**SUBJECT: MOD2021-0029 ORION DRIVE YAMBA NSW 2464**

**Public Consultation Submissions Response – Development Application MOD2021/0029 to Modify Development Consent under the State Environmental Planning Policy (Housing for Seniors and People with a Disability) 2004 – Make Amendments to Update Resort Layout and Design (DA2007/0884).**

**SECTION 4.55 AMENDMENT  
FILE REPORT FORM**

<b>FILE NO:</b>	DA2007/0884
<b>APPLICATION:</b>	MOD2021/0029
<b>APPLICANT:</b>	Palm Lake Works Pty Ltd
<b>OWNER:</b>	Palm Lake Resort Pty Ltd
<b>LEGAL DESCRIPTION:</b>	Lot 2 & Lot 3 in DP833711
<b>PROPERTY ADDRESS:</b>	Orion Drive YAMBA NSW 2464
<b>APPROVED DEVELOPMENT:</b>	78 independent seniors' living apartments

Figure 2: Elevations of modified clubhouse

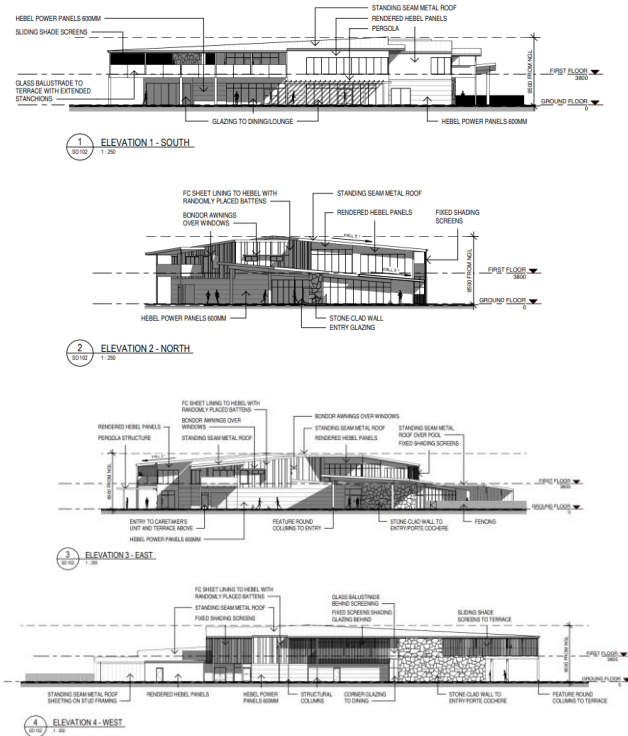
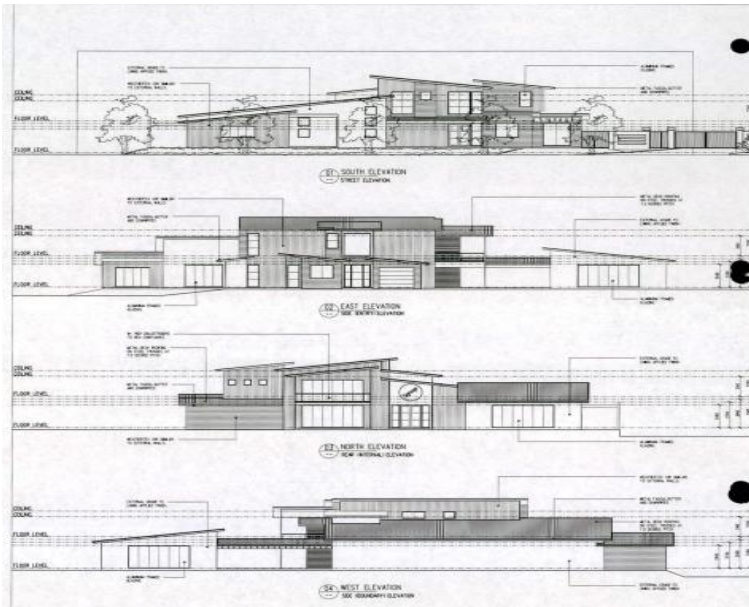
- **The modification proposed is not substantially the same as the original development (double storey club house, larger main entrance, 37% increase in 2 storey dwellings, development impacts, large retaining walls, accessibility issues).**

By comparison the footprint of the clubhouse and elevations show that while the clubhouse design has been amended it will present as a two-storey building and cover the same footprint in the (see figure 1 and figures 2 & 3).

Consent authorities are required to consider if a modification is substantially the same development (qualitatively and quantitatively) and whether the proposal is not a radical transformation to that approved. A S4.55 modification under the *Environmental Planning and Assessment Act 1979* also requires the consent authority to consider those matters listed in S4.15 which are required under a normal development application.
